# Access Compliance Report

## Public Rights-of-Way

### (Curb Ramps)

Intersection ID: 27926	Main Street: BRUNTSFIELD_PL	Cross Street: DAN_MAPLES_DR	Location: NW
ADA ID: 651E944E9163	Ramp Type: Perpendicular	Initial Pass/Fail: Fail	Overall Compliance: No
Severity Score: 22.5			
Codes/Mitigation Info/Possible Solution		Field Measurements/Component Compliance

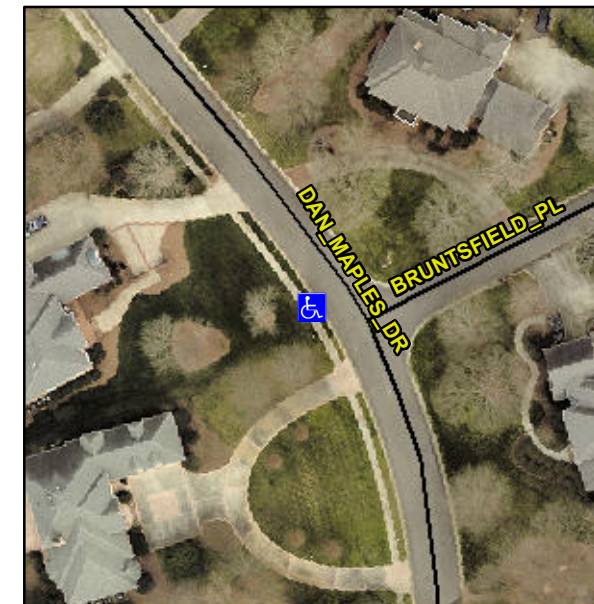
**Not Found, R304.5.1, R304.2.2, R304.5.3**

Compliance	Description	Data	Compliance	Description	Data
N/A	Ramp Length (in)	48.0	No	Ramp Slope (%)	9.2
No	Ramp Width (in)	47.0	No	Ramp XSlope (%)	2.1
N/A	Flare Type LT	N/A	N/A	Flare Type RT	N/A
N/A	Flare Slope LT (%)	N/A	N/A	Flare Slope RT (%)	N/A
N/A	Flare Traversable LT?	N/A	N/A	Flare Traversable RT?	N/A
N/A	Landing Length (in)	N/A	N/A	DWS Provided?	N/A
N/A	Landing Width (in)	N/A	N/A	DWS Contrast?	N/A
N/A	Landing Slope (%)	N/A	N/A	DWS Length (in)	N/A
N/A	Landing X Slope (%)	N/A	N/A	DWS Full Width?	N/A
N/A	Landing Curb? (Y/N)	N/A	N/A	DWS Offset (in)	N/A
N/A	Shared Landing?	N/A			
N/A	Gutter Ponding?	N/A	N/A	Gutter Slope (%)	N/A
N/A	Gutter Lip Ht (in)	N/A	N/A	Gutter X Slope (%)	N/A
N/A	Painted X Walk1?	No	N/A	Painted X Walk2?	N/A
	X Walk 1 Direction	To E		X Walk 2 Direction	N/A
N/A	X Walk 1 Width (in)	N/A	N/A	X Walk 2 Width (in)	N/A
	X Walk 1 Slope (%)	1.6		X Walk 2 Slope (%)	N/A
	X Walk 1 X Slope (%)	0.1		X Walk 2 X Slope (%)	N/A

**Remove & Replace Entire Ramp.**
